TECHNICAL BULLETIN

[Issue No.] GOT-A-0102-A

[Title] Rating Plate and Caution Plate Changes of GOT2000 Series Compliant with Overseas Standards

[Relevant Models] GOT2000 Series (GT27 Models, GT25 Models)

1.1 Rating plate

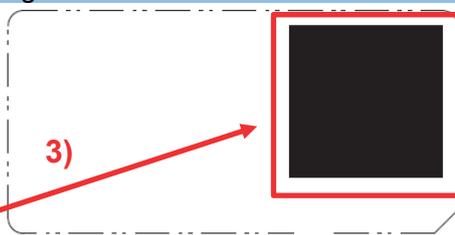
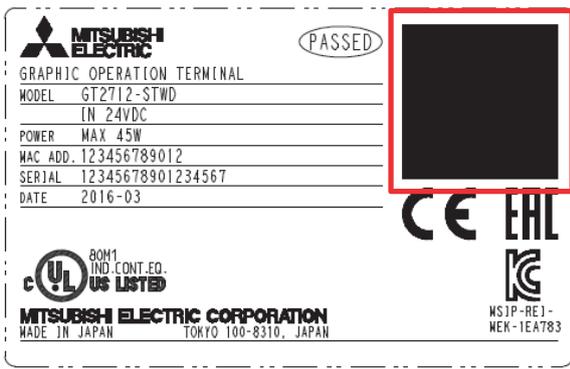
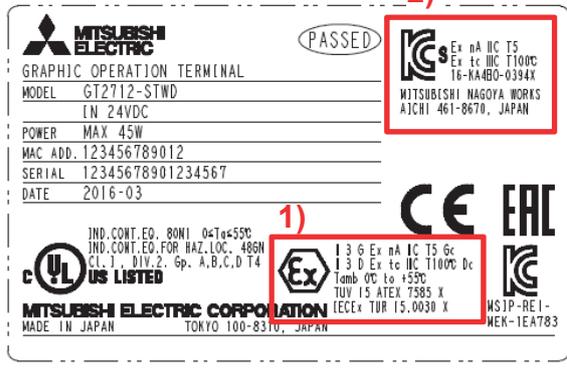
- 1) The Ex mark, use environment, and certification number have been added.
- 2) The KCs mark, use environment, certification number, and address of factory have been added.
- 3) The QR code has been relocated.

1.2 Warning and caution plates

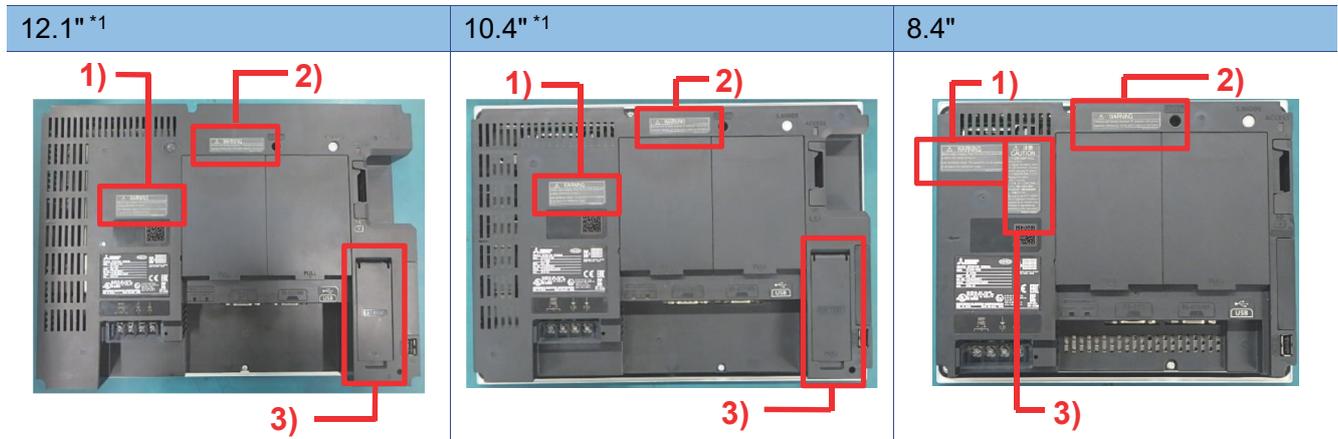
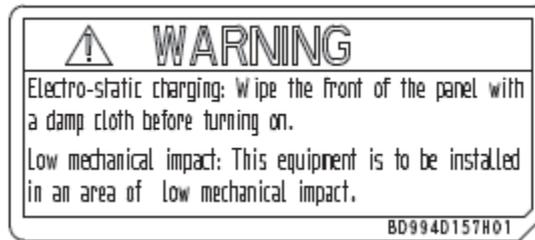
Two warning plates have been added, and the descriptions on the battery caution plate have been changed.

1) A warning plate about static electricity and low mechanical impact has been added.

2) A warning plate about the restrictions on using the extension interface has been added.

3) The descriptions on the battery caution plate have been changed.
